**MEMORANDUM**

**REVIEW TYPE:** Site Plan Review

**PROJECT NAME:** **8045 Newell Street**

**CASE #:** 8-03037

## Phase III: Kennett Links

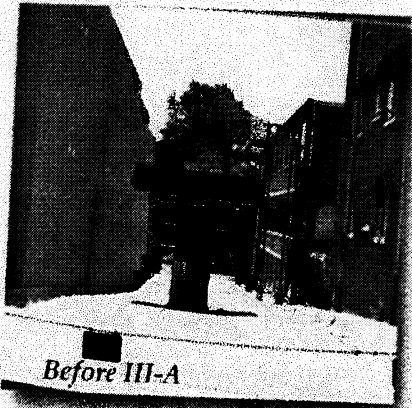
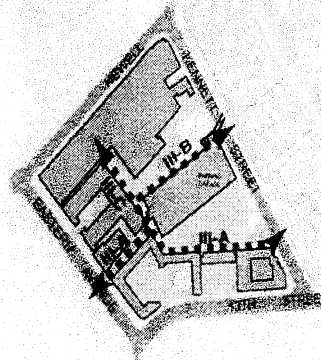
The applicant, in coordination with DHCA, DPWT, Discovery Communications and the M-NCPPC planning staff, has agreed to design, construct and provide an easement for pathway III-B located in the public space between the proposed development and the County Garage 9 to the south. This fulfills the condition by the Planning Board to *"coordinate and participate financially with the Department of Housing and Community Affairs (DHCA) for the study and construction of an integrated path system on the County property adjacent to the parking garage and connecting Kennett Street and Eastern Avenue"*. The improvements include a concrete path, lighting and landscaping. The applicant has also agreed to provide an easement for the potential future implementation of pathway III-C located between the proposed development and Robbins Building to the west.

- c. Provide details and specifications for M-NCPPC staff review and approval for the pathway on the adjacent county property prior to signature set of site plans. The details of the plan must include the pathway, landscaping, lighting, benches and other appropriate amenities, in accordance with an agreement between the applicant, Montgomery County Department of Housing and Community Affairs and Montgomery County Parking Authority [See letters from DHCA, Appendix B];
